**Re: Stoneham High School**

*District's Response to the  
Preferred Schematic Report Review Comments*

**ATTACHMENT A**  
**MODULE 3 – PREFERRED SCHEMATIC REPORT REVIEW COMMENTS**

# ENVIRONMENTAL BUFFERS

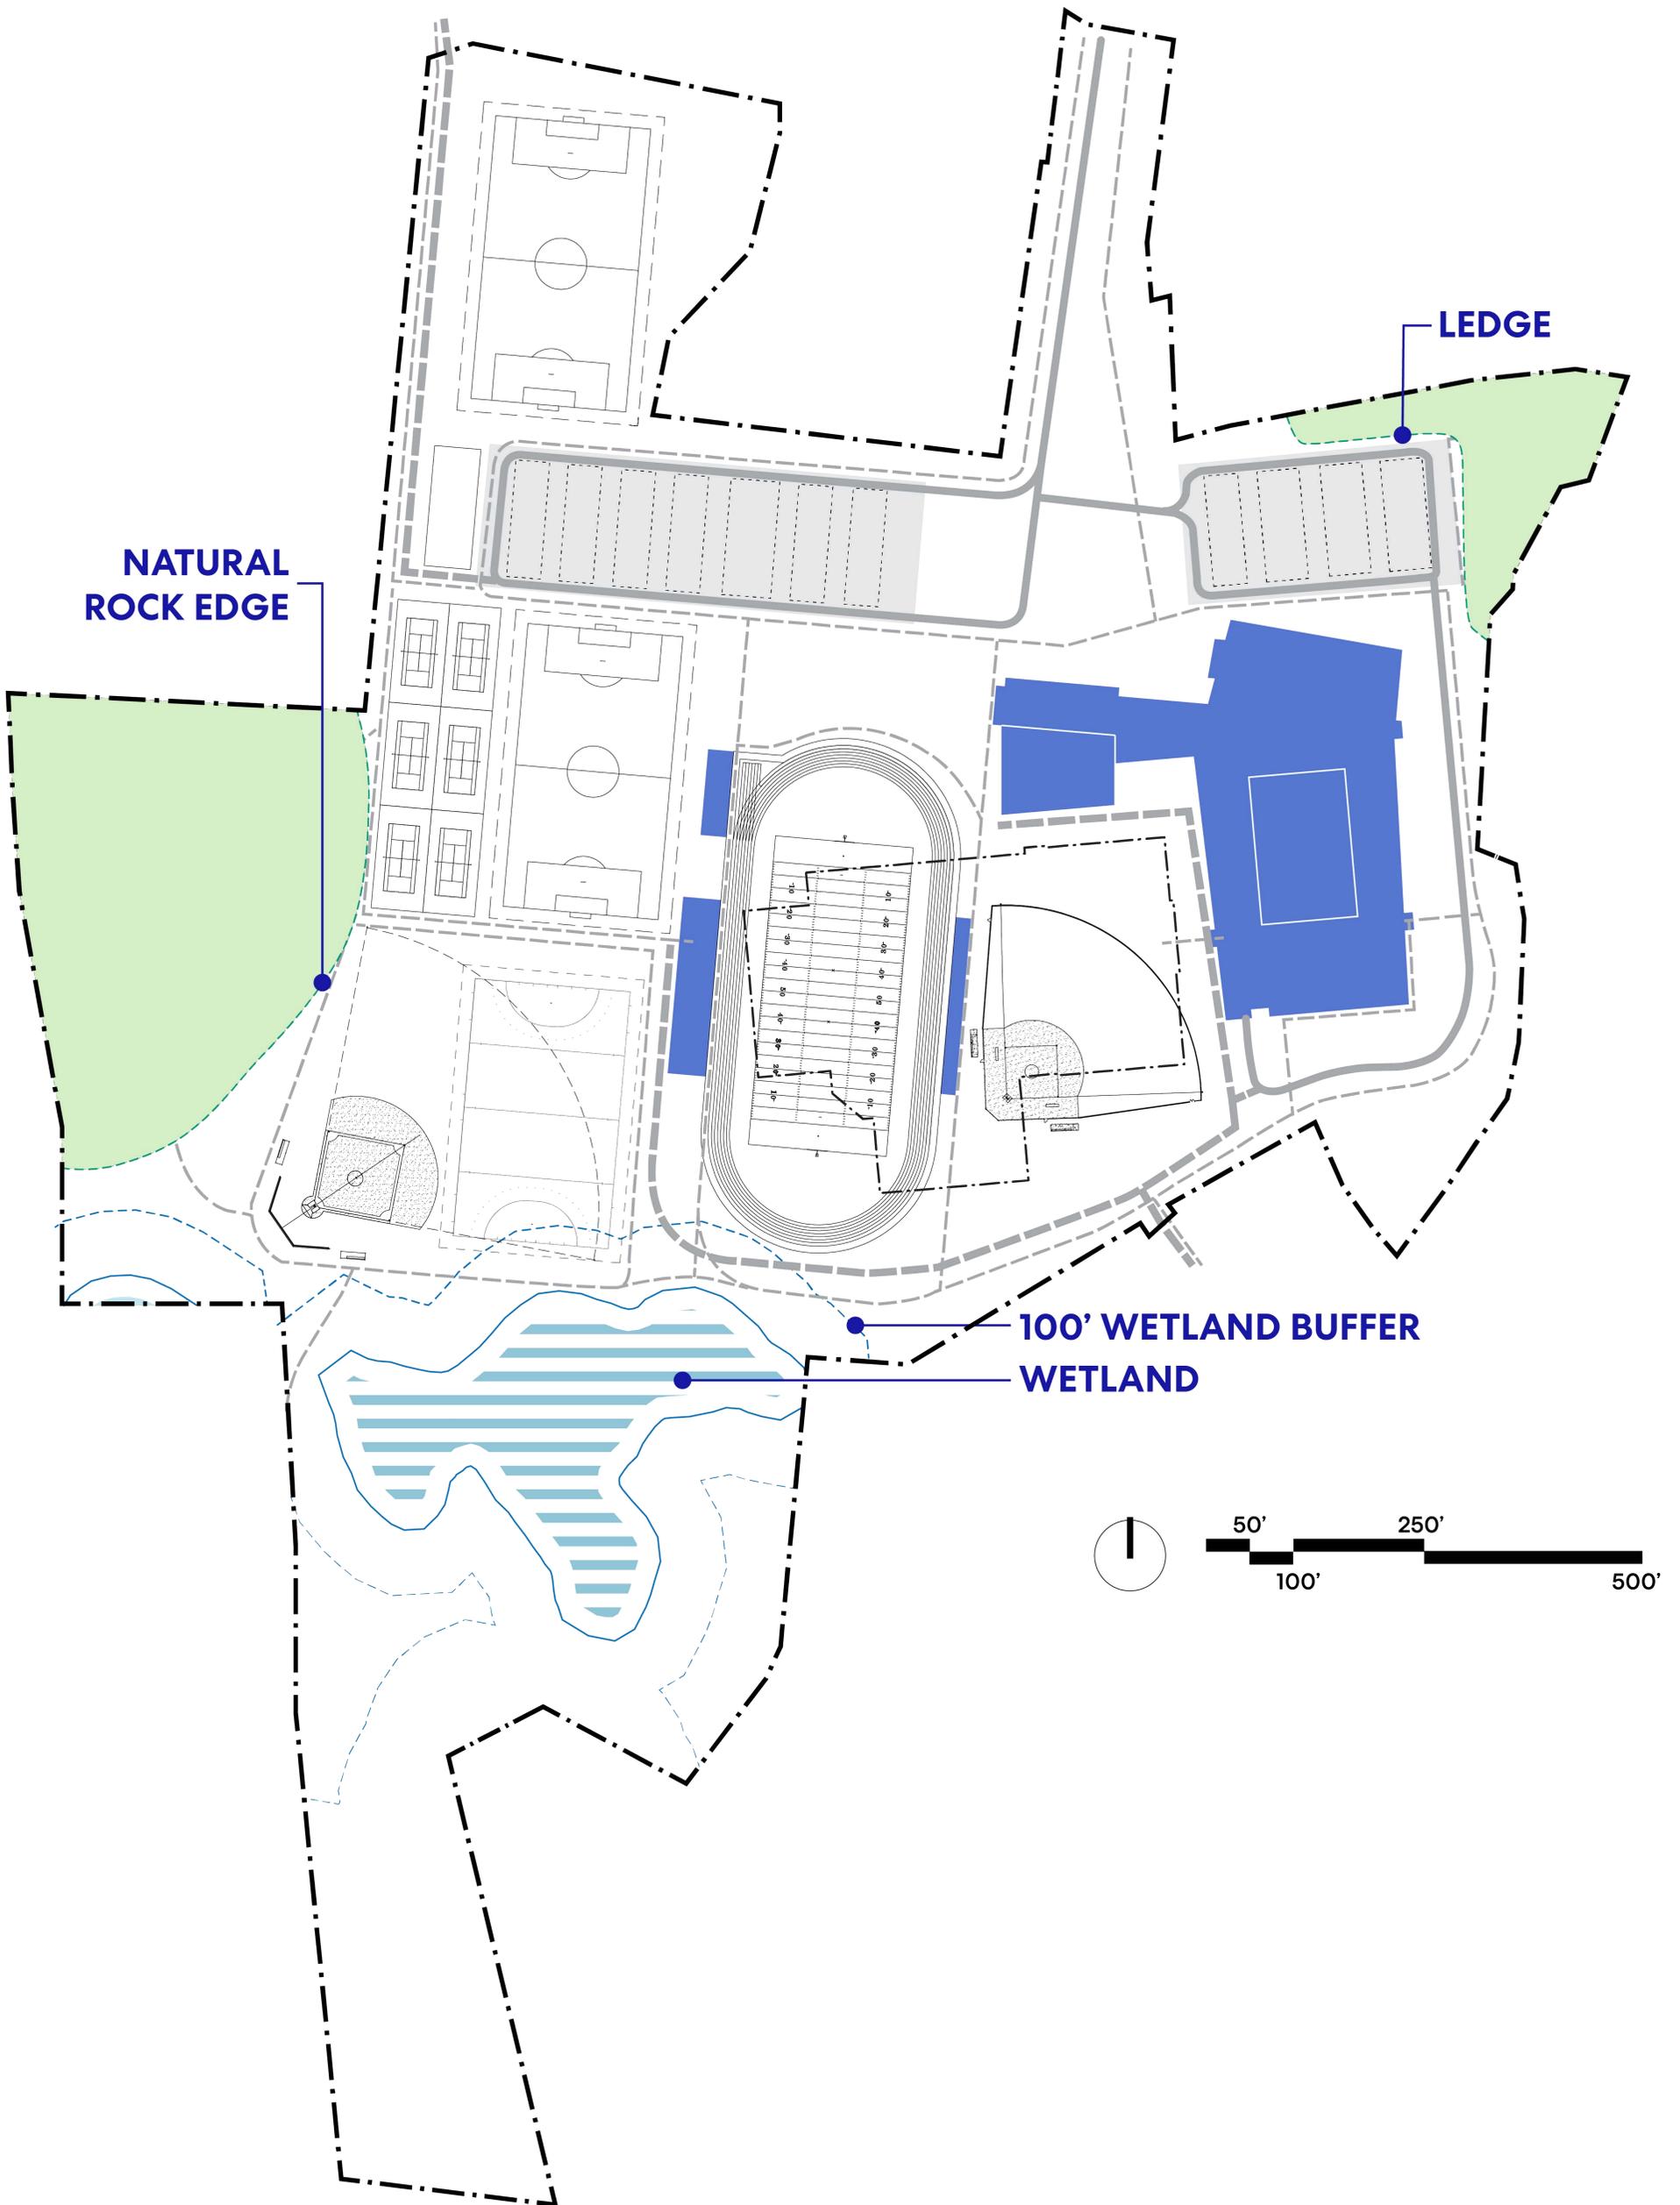
5e) *The information provided discusses environmental concerns within the narratives. In response to these review comments, provide site plan diagrams that identify any easements and/or environmental buffers.*

**Response: Environmental buffer diagram attached.**

# SAFETY & SECURITY

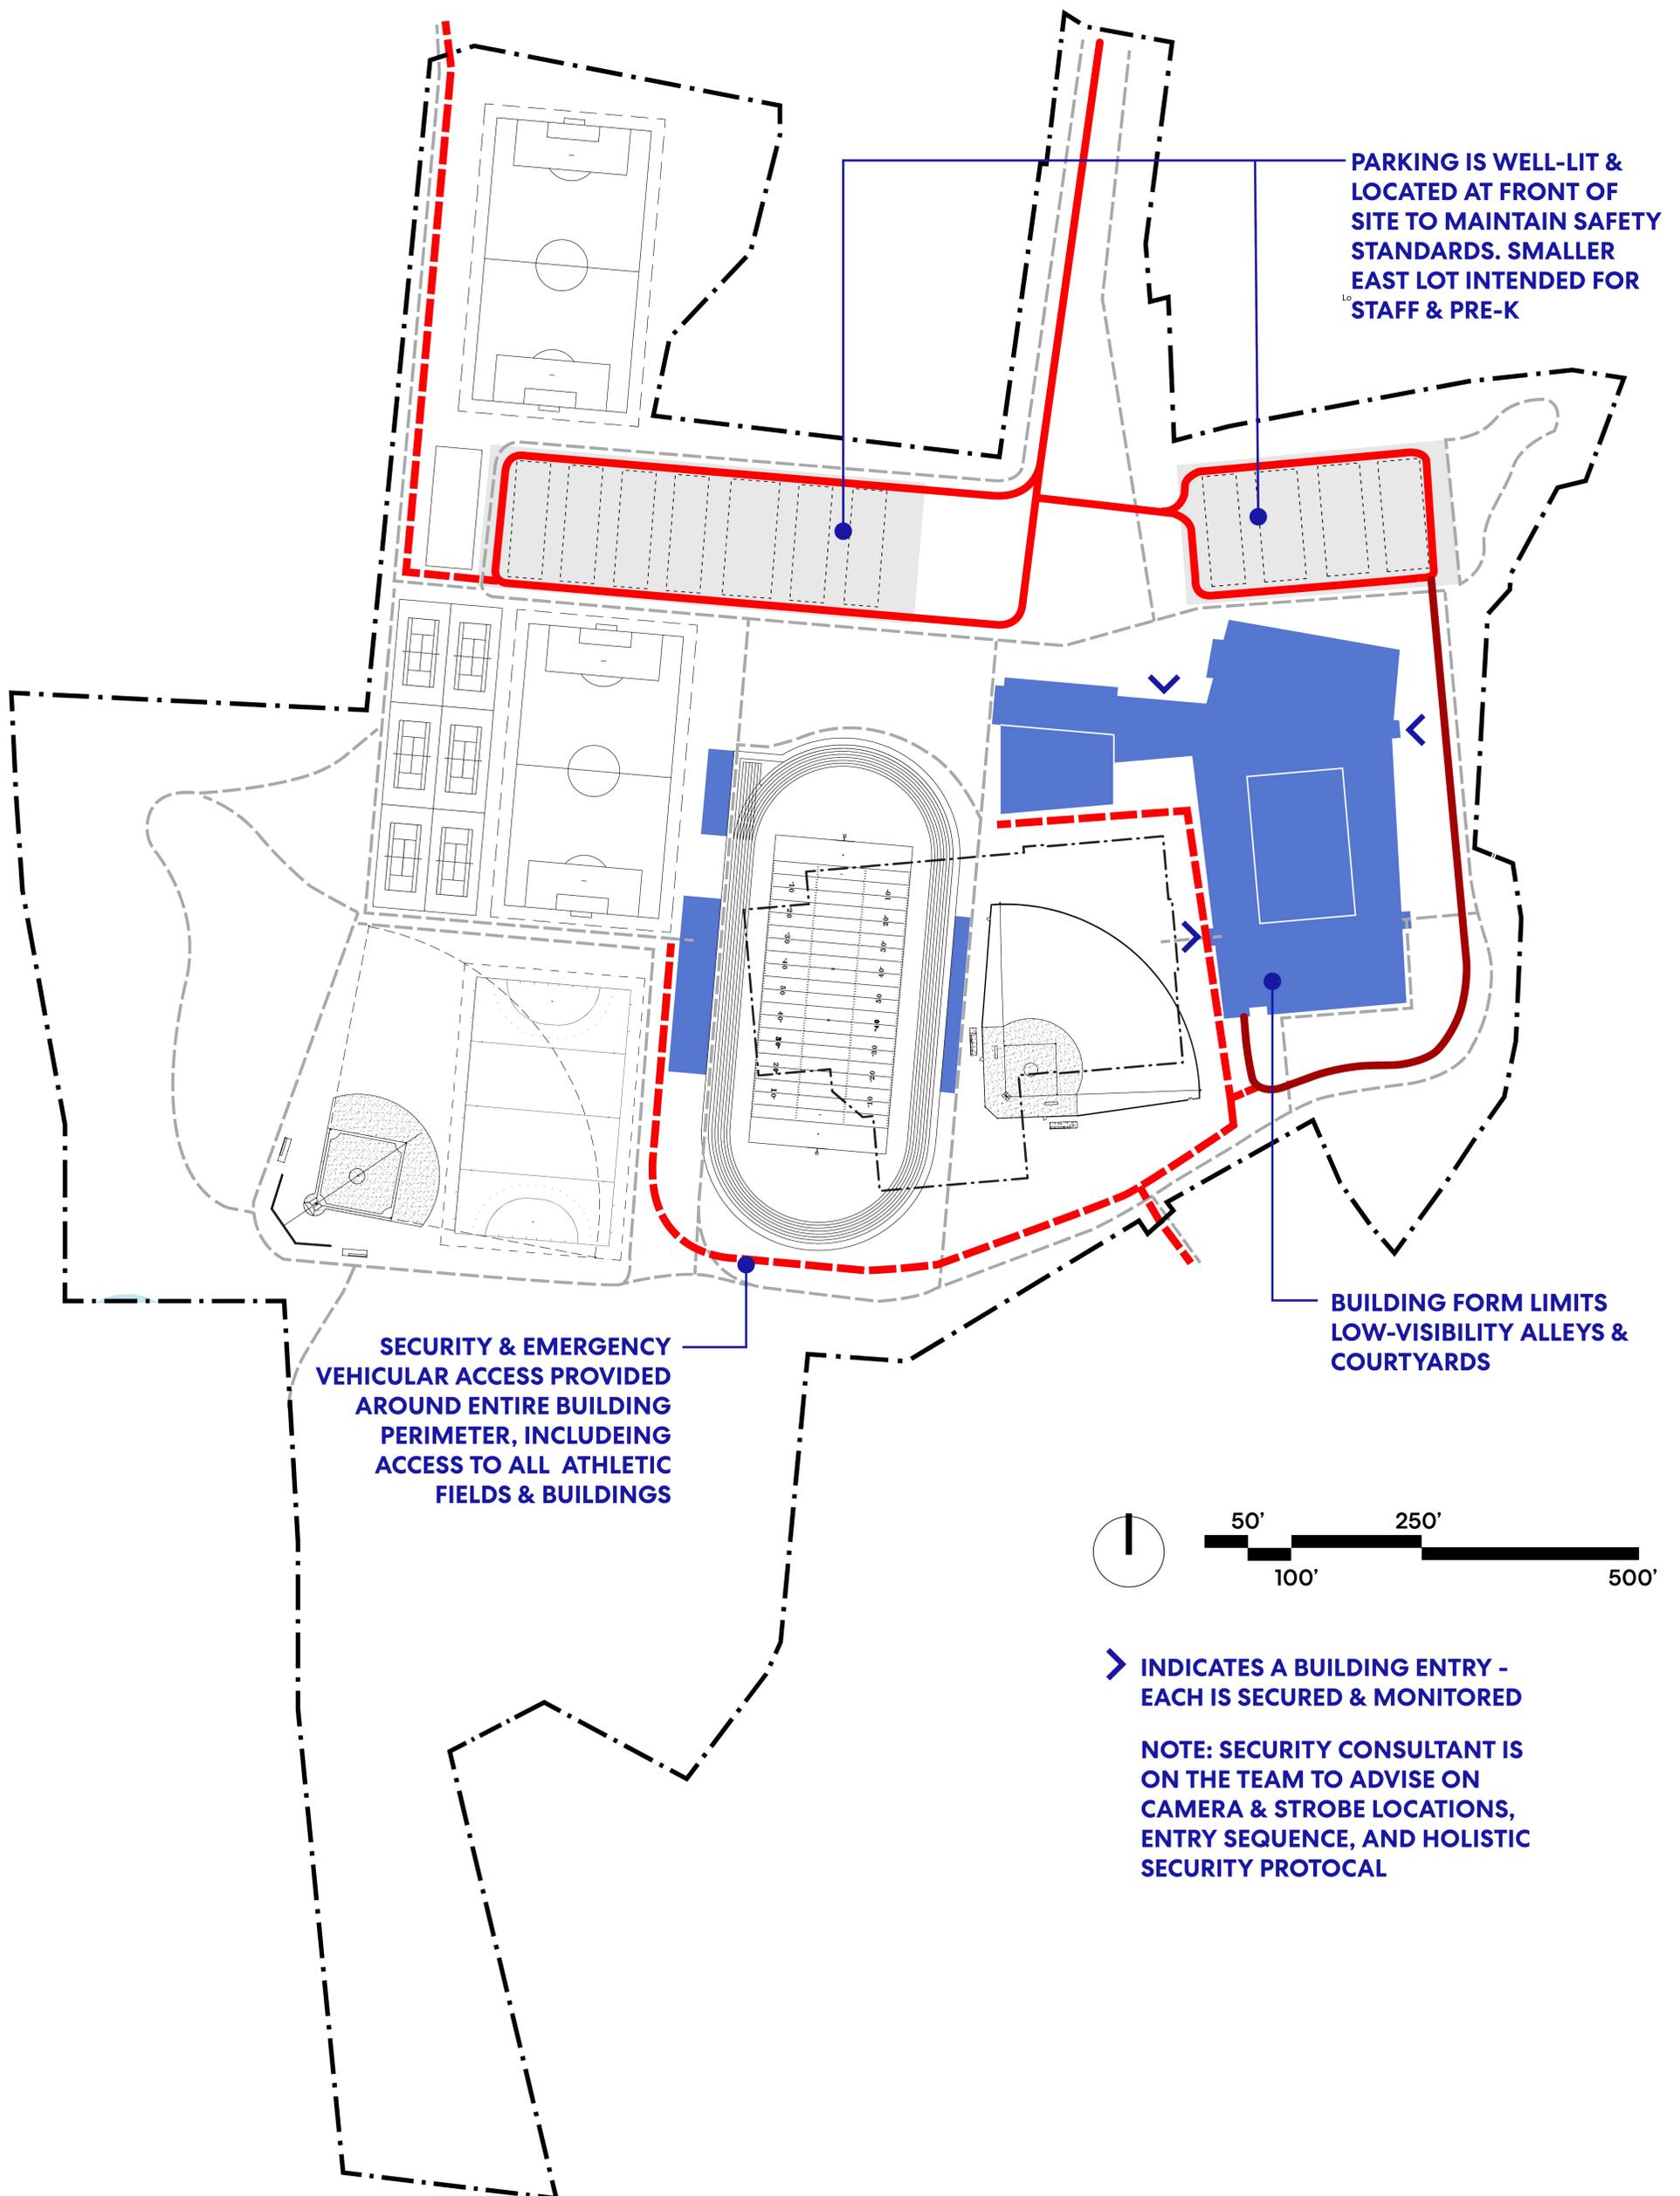
5g, h) *In response to these review comments, provide site plan diagrams that identify safety and security features and utilities.*

**Response: Safety and security features and utilities diagrams attached.**
